Centre Plan Package A | Resident Submissions

(February 23 – May 8, 2018)

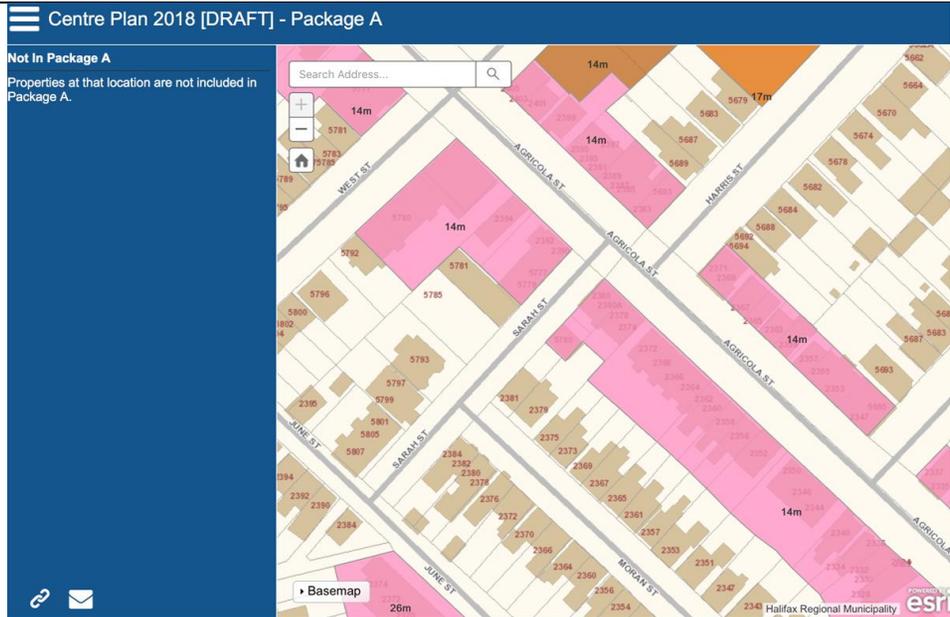
Subsequently the rezoning of XXXX and XXXX Duffus St as HO-1 I believe is a mistake as these are single family dwellings which are not owned by the developer proposing a large mixed commercial /residential complex at the corner of Robie and Duffus Streets. The properties act as a buffer which is so important for the 5 residential properties that border it which includes the streets Agricola, Duffus and Hillside Ave.

Reference A

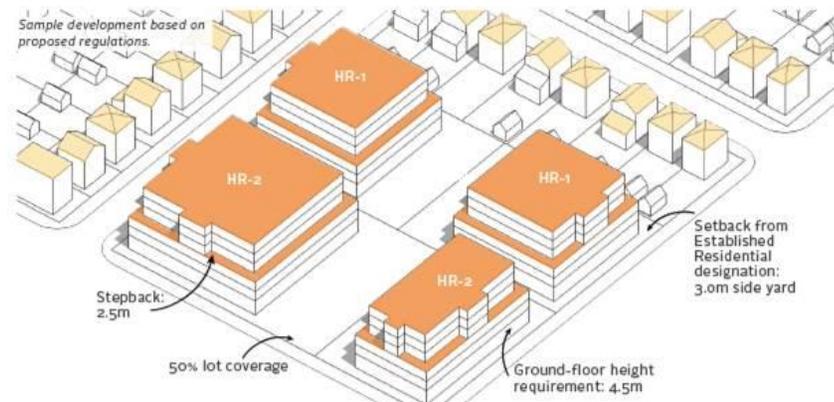
buildings will look from the street and what the interaction with the street is. It is clear a lot of thought has gone into how developments are viewed from neighbouring properties and the street. The plan also identifies corridors which would work functionally well with transit, but will people want to live in these developments? If we want to encourage more people to live in denser urban environments rather than moving to a house in the expanding suburbs, we need to think about the potential views *from* the new buildings. Too many current residential developments in Halifax offer the option of a view of the street or a view of a parking lot. Can the centre plan do something to redirect this design?

- Is there anything I'm missing which might encourage developers to use 'yards' as green or garden space rather than parking?
- Future Growth Nodes clearly offer opportunity for master plan designs with parkland but is there anything which might encourage developers to work with neighbouring developers to create something they couldn't create on their own?
- Referring to the higher-order residential zones fact sheet (Reference A below) and assuming the four blocks shown represent four different developers, is there anything which could encourage developers to build these together (perhaps in a semi-continuous U shape, with a park in the centre)?
- Although on a much larger scale, I'd also like to refer to Park Central (Birmingham, UK) as an example of high density urban residential built with green space in mind (Reference B below)

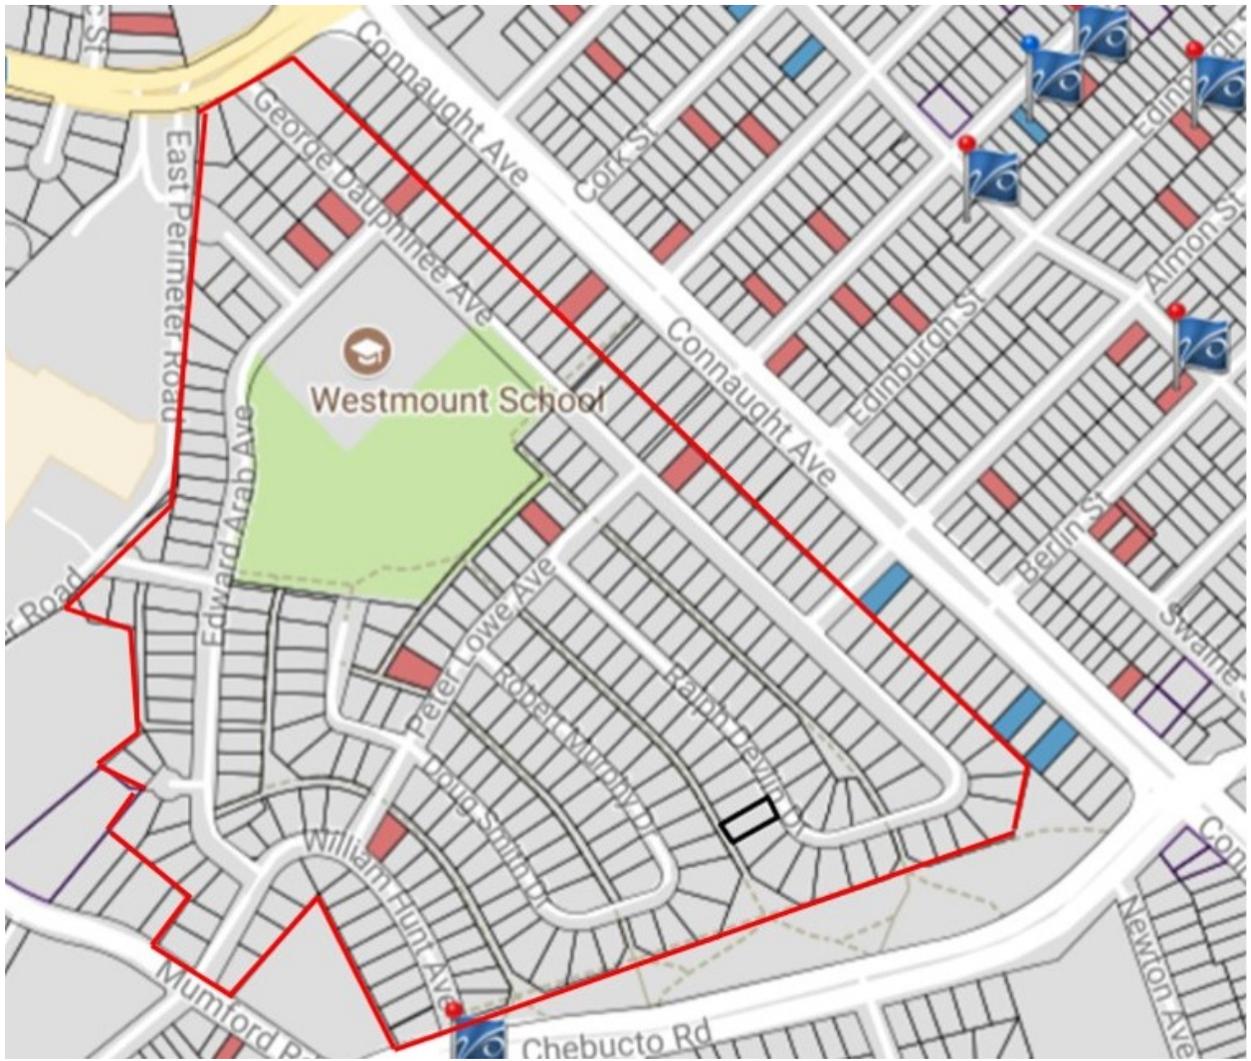
In respect to the Urban Structure Map depicting the proposed Westmount Heritage Conservation District we believe the boundaries of the heritage district are not extensive enough. The proposed boundary does not physically coincide with the actual memorial and heritage extent of the neighbourhood, nor does it coincide with what a resident of the area does consider to be "Westmount". We feel it important that the boundary of the study area be widened, at least at the outset, if for no other reason that it is easier to reduce a boundary after further study, then it is to increase its size at a later date.

We therefore propose that the Urban Structure Map be altered to slightly expand the proposed Heritage Conservation District. We have attached a map suggesting how we believe the Westmount study area should be defined.
